Technical Service Bulletin: TSB120247

New Piston and Piston Second Ring

This document announces the release of a new piston and piston second ring for use on QSK60 and QSK45 Tier 1 Diesel engines.

**Figure 1, Top Land Diameter Measurement**

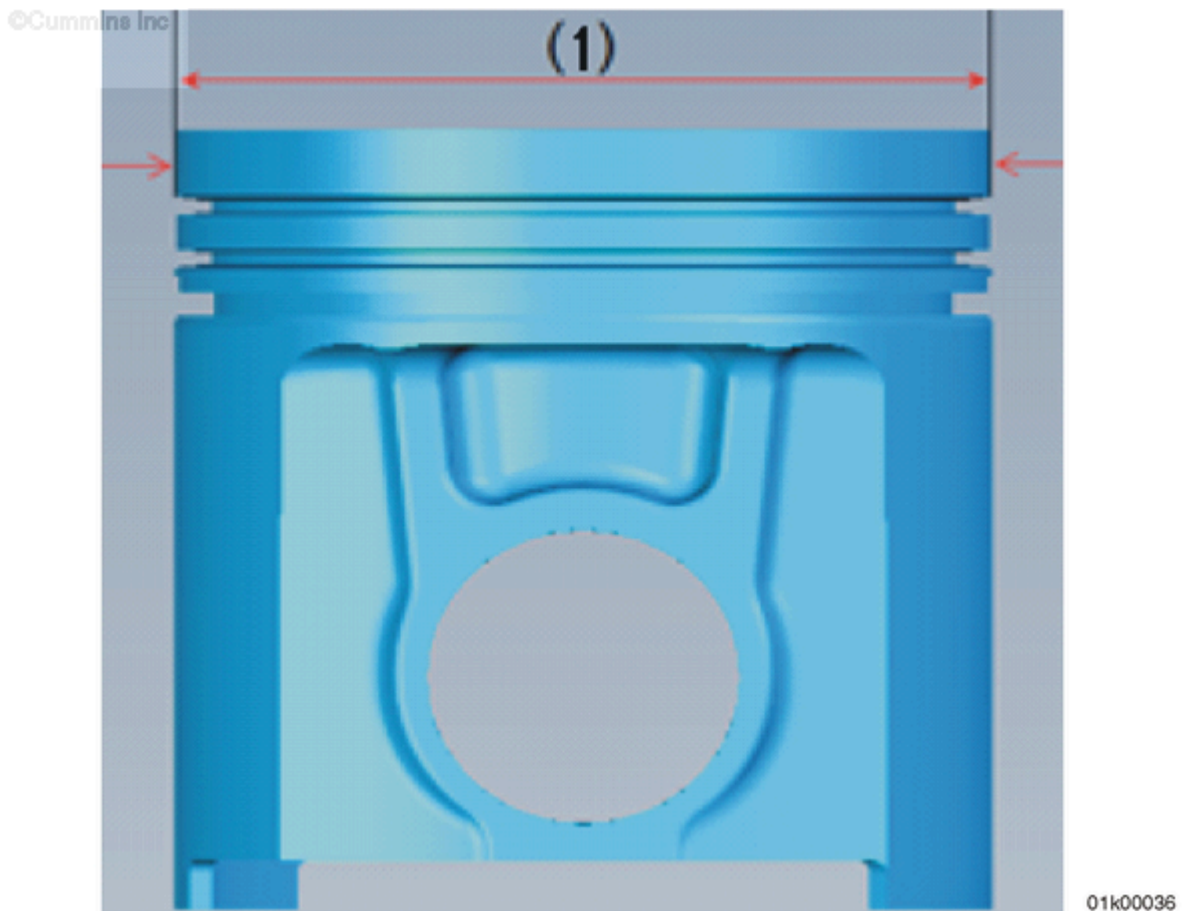
The new piston has a cut back top land to prevent carbon buildup in this area.

The new piston can be identified from the present one by the difference in the piston top land diameter (1). The new piston has a smaller diameter than the present one. Reference Table 2, for top land diameters of the new and present pistons (measured at the center of the top land).

Table 2: Top Land Dimensions				
Piston Part Number	Top Land Diameter (1)			
	Min		Max	
	mm	in	mm	in
3640474 (present)	156.91	6.178	157.01	6.181
3645958 (new)	155.71	6.130	155.81	6.134
